**City of Ramsey**  
**Agenda**  
**Environmental Policy Board (EPB)**  
**Monday, February 25, 2019**  
**6:30 pm**  
**Council Chambers, 7550 Sunwood Drive NW**

**ITASCA ESTATES**  
 Ramsey, Minnesota

**PRELIMINARY GRADING & EROSION CONTROL PLAN**

**CITY OF RAMSEY LAND USE APPLICATION  
TECHNICAL REVIEW FILE**

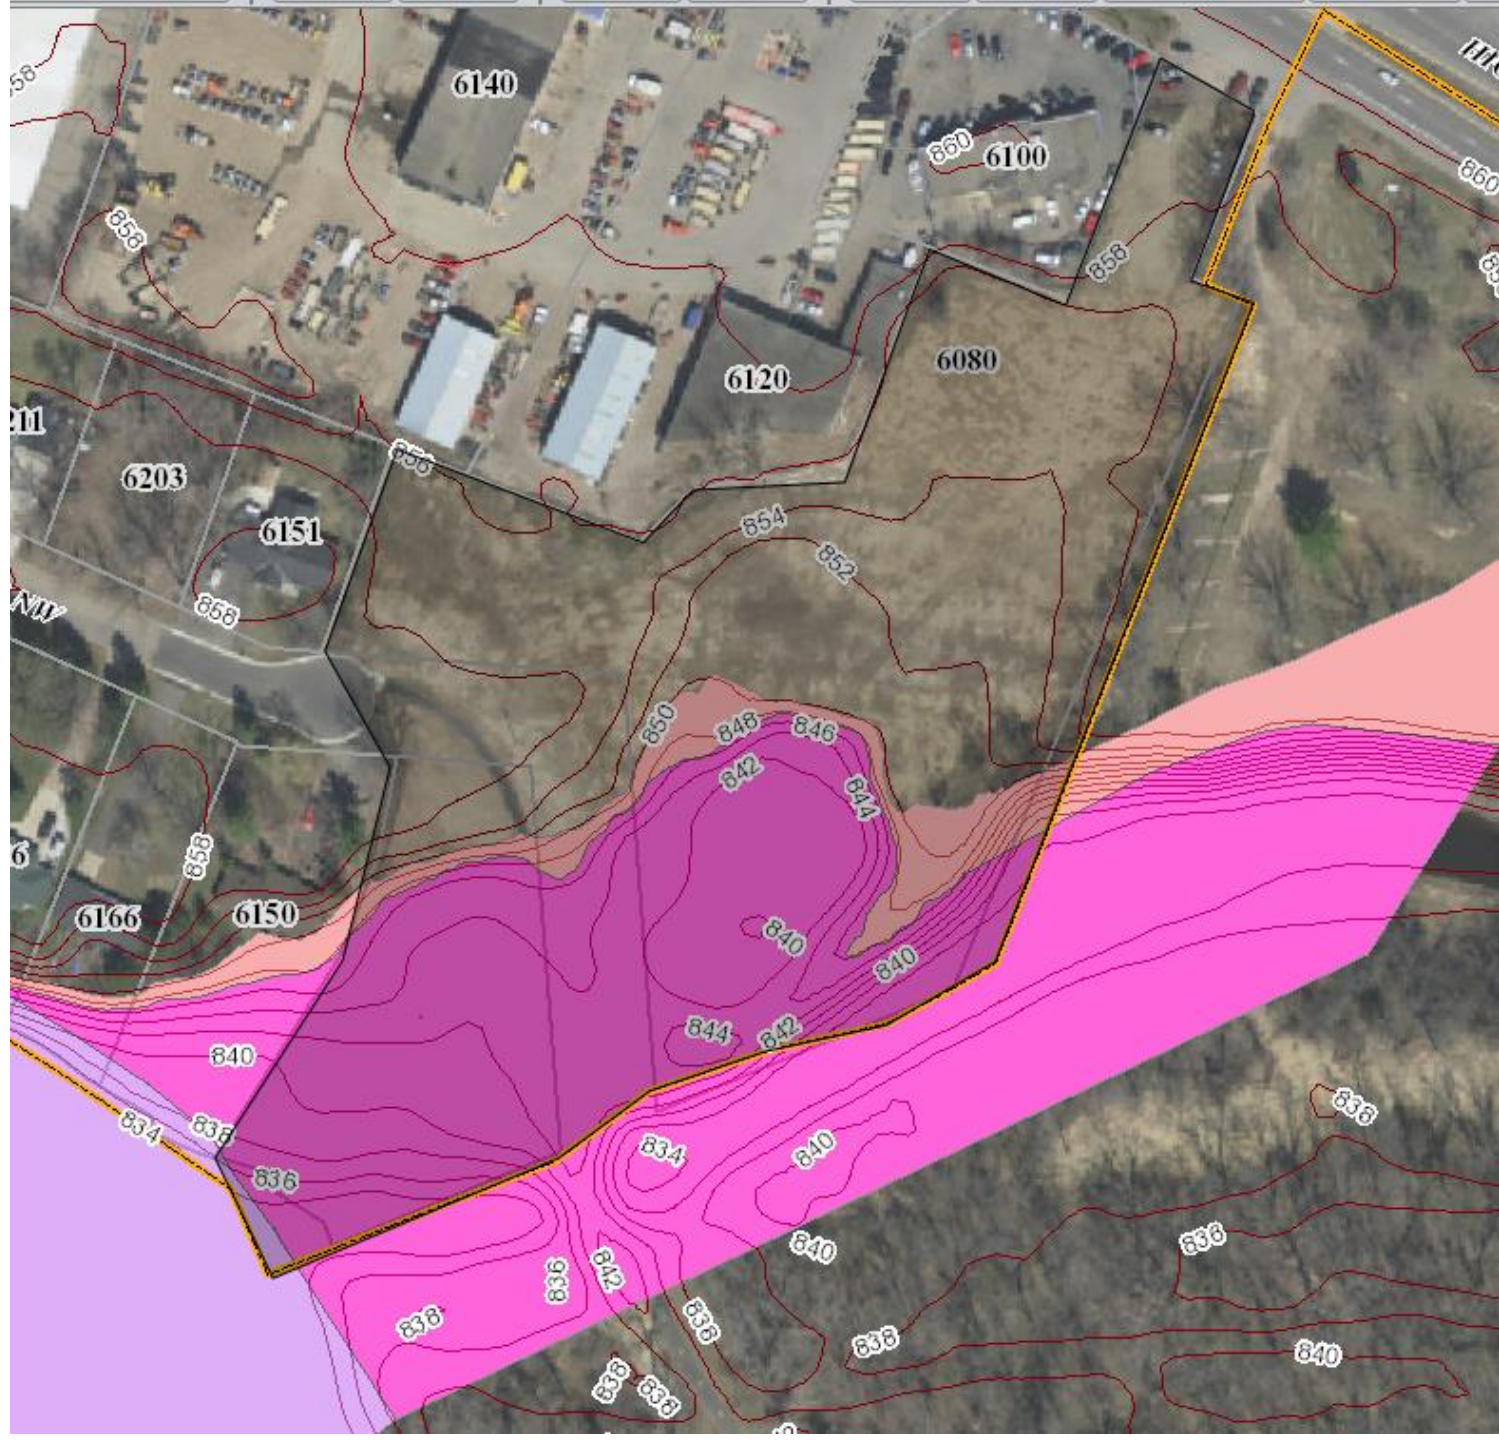
**Sheet 5 (Grading & Erosion Control)**
